## PLANNING & COMMUNITY DEVELOPMENT DEPARTMENT

### STAFF REPORT

**SUBJECT:** Hillside Development Permit #7013

**LOCATION:** 625 Rockwood Road

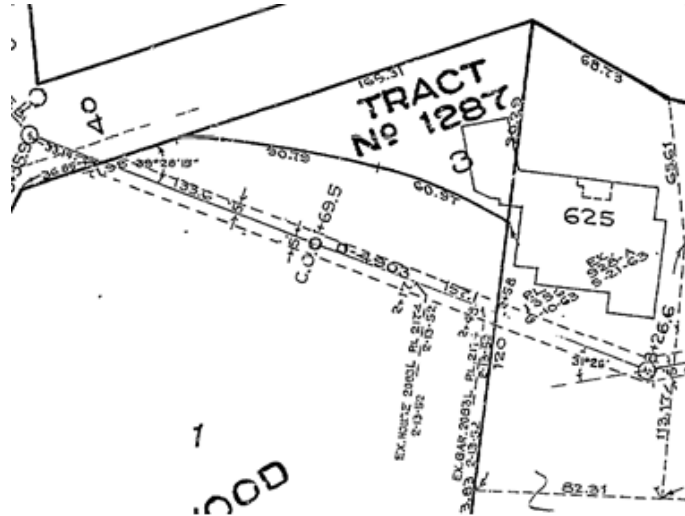
28. There is an existing 10-ft wide sewer easement within the property with a sewer manhole, see illustration below. Said easement and manhole shall be shown on all construction drawings. No new construction shall encroach into the easement.
